Ref: My application no. 10/042,433. (B.Gopinath)

Your office communication d. April 6,2004.

Embodiment 3. Device with inclined cutting action page 7 of amended specs, fig.no.7.

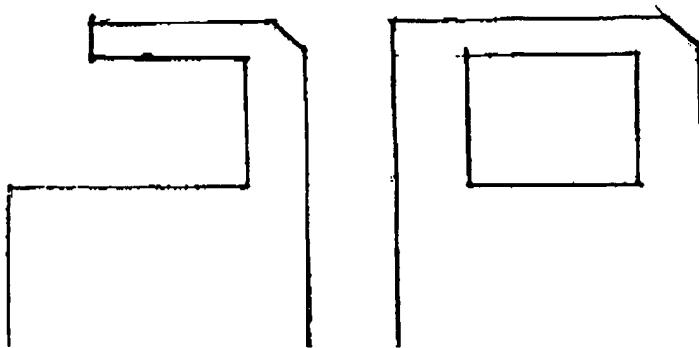
I wish to amend the shape of part 6, guide which is now closed on three sides and open at the left, knife side. I plan to make it closed on four sides, like a rectangle. See Sketch.

This is being done to strengthen it.

There is no change in the way the device operates because of this.

The change has a support in the as filed spec/drawing. No new part is added. Only the existing part is amended to strengthen it.

If you say this will be admissible I will amend the drawing and send a replacement sheet.
